Access Compliance Report Public Rights-of-Way (Curb Ramps)

Main Street: PACIFIC_AVE Cross Street: MAGNOLIA_AVE Location: NE

ADA ID: RPAT211129103724 Ramp Type: Type 1 - Perpendicular Initial Pass/Fail: Pass Overall Compliance: No Severity Score: 4

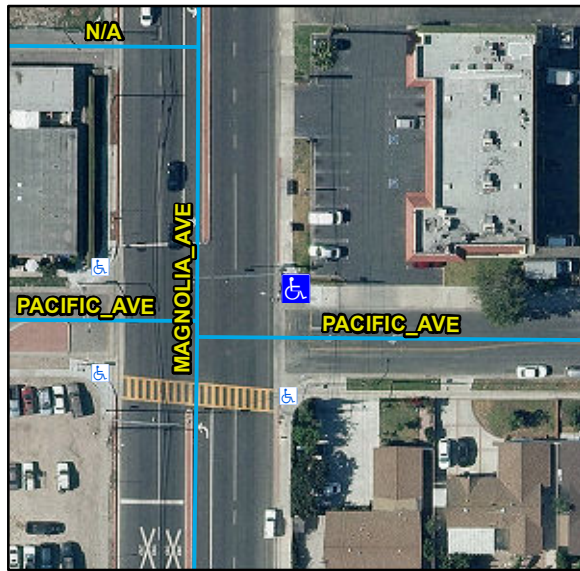
Possible Solutions:

Remove & Replace Landing. Utility Present.

R304.2.1, R304.5.3, STD 1115
